Amendment No.3

SUBJECT: USC-IFB-DG-3038/ Provide all Labor, Materials and Equipment for Athletic Field Maintenance for the USC Strom Thurmond Wellness Center & Blatt PE Center

DATE: October 17 2012

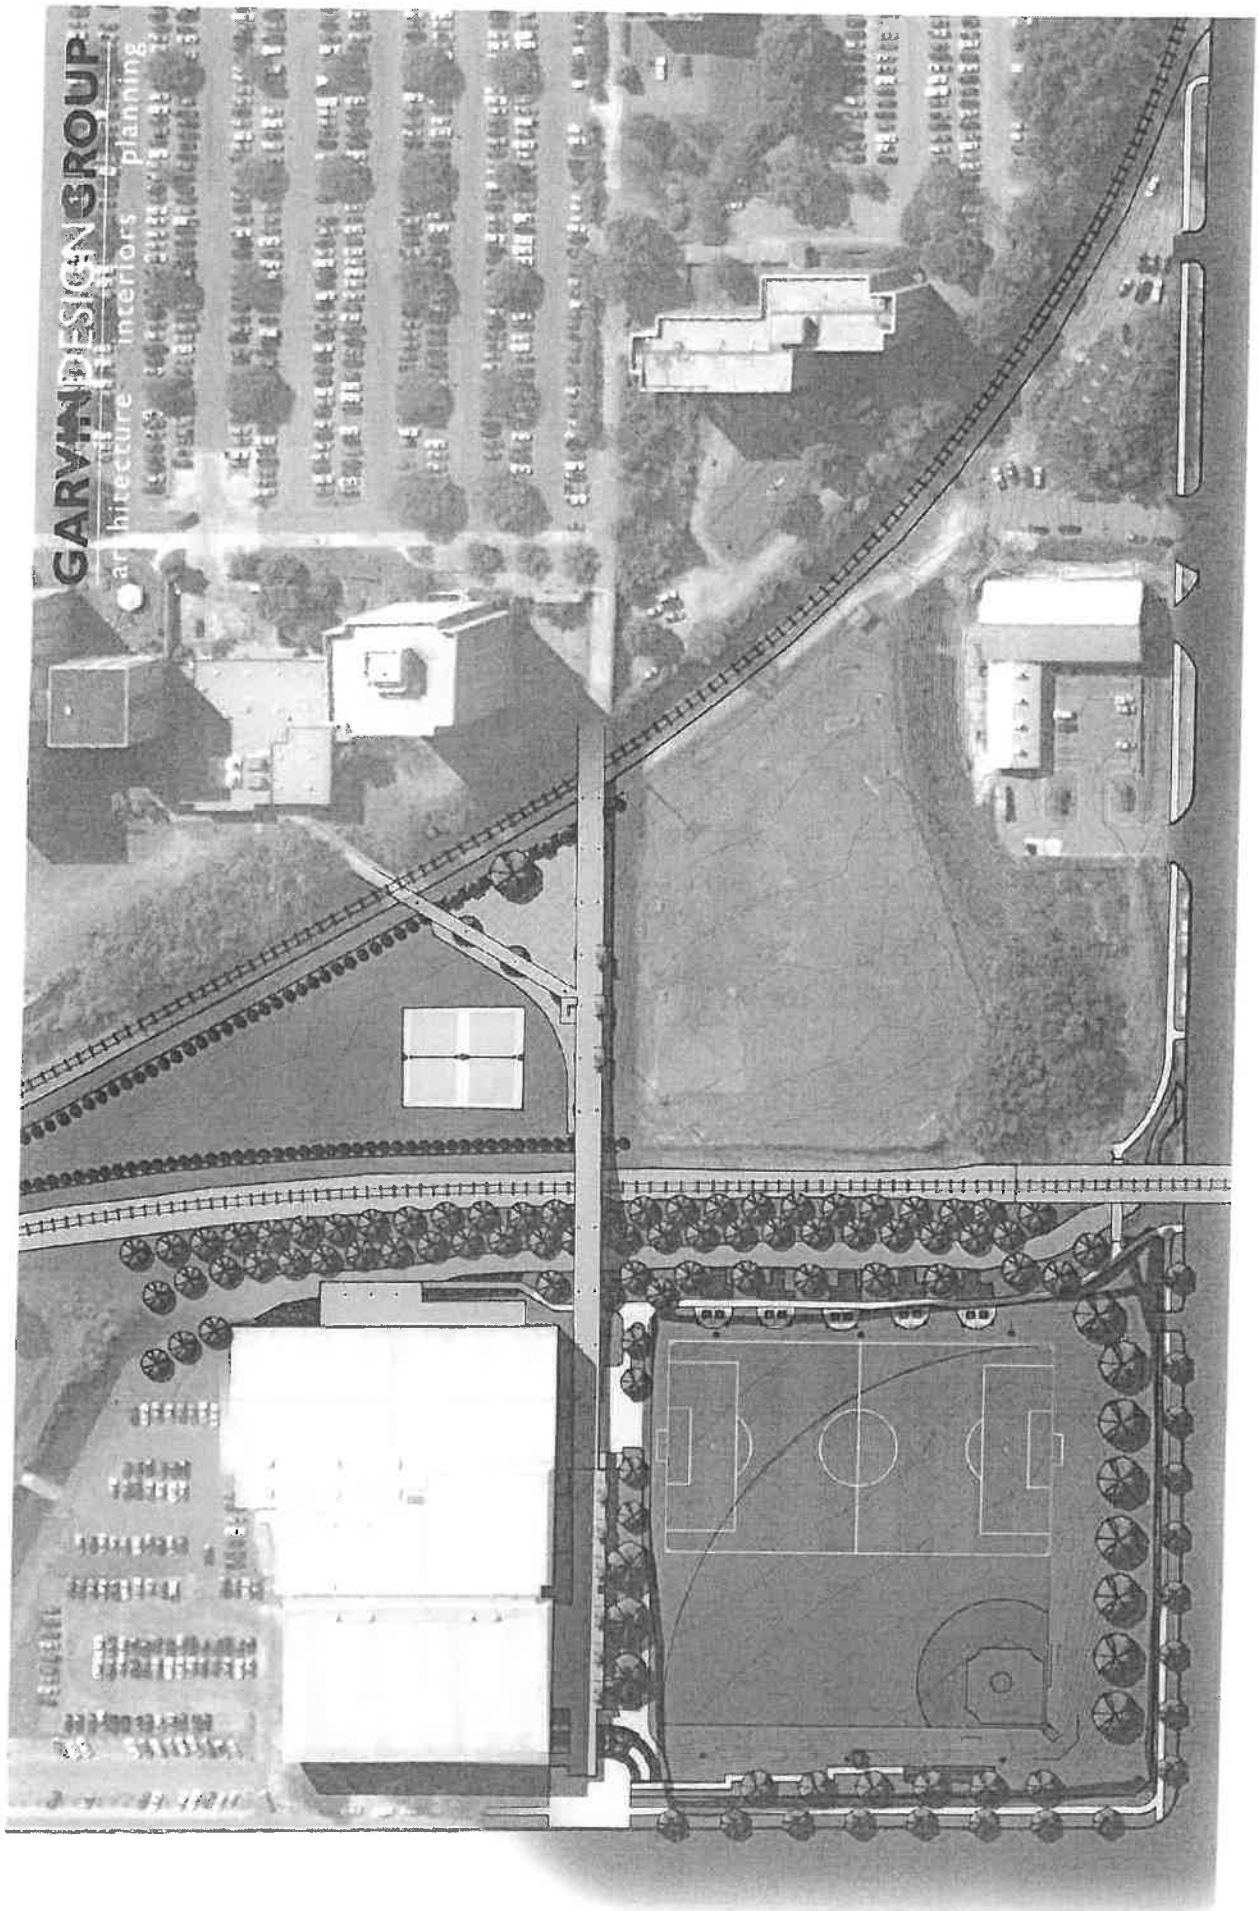
- 2) Can the University provide a site map with the exact areas to be maintained highlighted or designated somehow as part of this bid packet? There was discrepancy in the areas to be maintained as part of No 2 Normal Turf Maintenance at the Wellness Center.

Answer: The square footage has been verified, and at the Strom Thurmond WFC it includes all of the turf/grass within the sidewalks. We have also verified the square footage of the PE Center. We will need to increase the area receiving "normal" maintenance to approximately 28,000 sq. ft.

A map is attached.
